## Issue List

05-26-25 CAVA WARWICK, RI

**Issue Name :** 1. RTUs On Incorrect Curbs

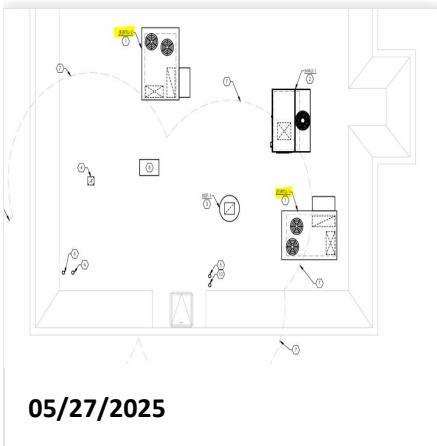
**Description :** The "48FCD09" unit is serving the Dining Area and the "48FCDN12" unit is serving the Kitchen. Per the mechanical plans, the larger unit is supposed to serve the Dining Area. To achieve proper cooling of the space, these units will need to be swapped.

- **05/27/2025 National TAB - Stephen Tassinaro**
  - Currently both units will be balanced to 400CFM/Ton respectively. This will not match the designs shown on the mechanical plans since there is now 4000CFM in the kitchen instead of 3400CFM. And 3400CFM in the dining room, instead of the original 4000CFM. All diffusers will be proportionally balanced.

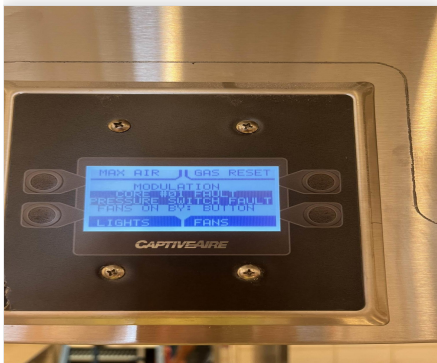
**Issue Name :** Excessive Flex Runs  
**Description :** The flex duct runs above the restrooms and adjacent hallway are beyond the 5' maximum.  
**Created By :** National TAB                      **Assigned To :** National TAB - Will Turnbough  
**Status :** Open  
**Priority :** High                                      **Asset Tag :**  
**Originated Date :** 05/28/2025 - Stephen Tassinaro - National TAB

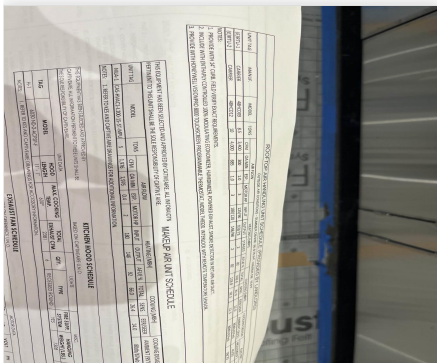
**Issue Name :** Hood "Core #01 Fault"  
**Description :** The kitchen hood HMI is displaying "Core #01 Fault". This did not effect the balancing of the hood.  
**Created By :** National TAB                      **Assigned To :** National TAB - Will Turnbough  
**Status :** Open  
**Priority :** InfoOnly                                      **Asset Tag :**  
**Originated Date :** 05/27/2025 - Stephen Tassinaro - National TAB

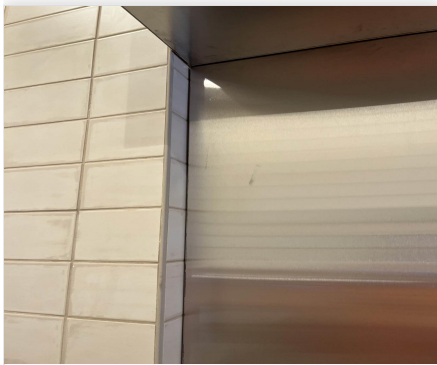
**Issue Name :** Incorrect Thermostats  
**Description :** The currently installed thermostats are not the correct model and do not have all the desired functions (occupancy, humidity, remote sensors, exc). The current thermostats are can schedule just temperature setpoints.  
**Created By :** National TAB                      **Assigned To :** National TAB - Will Turnbough  
**Status :** Open  
**Priority :** High                                      **Asset Tag :**  
**Originated Date :** 05/28/2025 - Stephen Tassinaro - National TAB

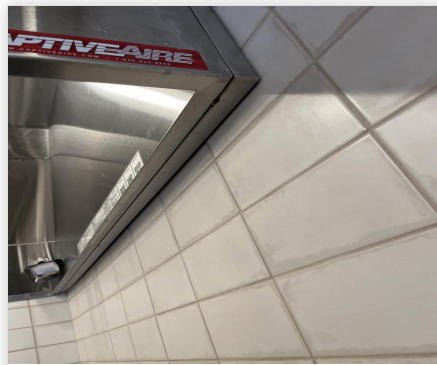
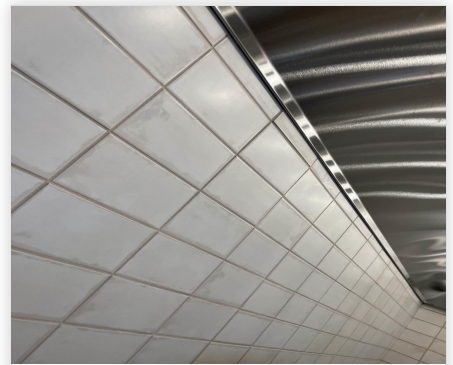
**Issue Name :** Kitchen Hood Not Caulked  
**Description :** The kitchen hood should be caulked at all points in which it touches the wall to prevent grease accumulation.  
**Created By :** National TAB      **Assigned To :** National TAB - Will Turnbough  
**Status :** Open  
**Priority :** Low      **Asset Tag :**  
**Originated Date :** 05/28/2025 - Stephen Tassinaro - National TAB
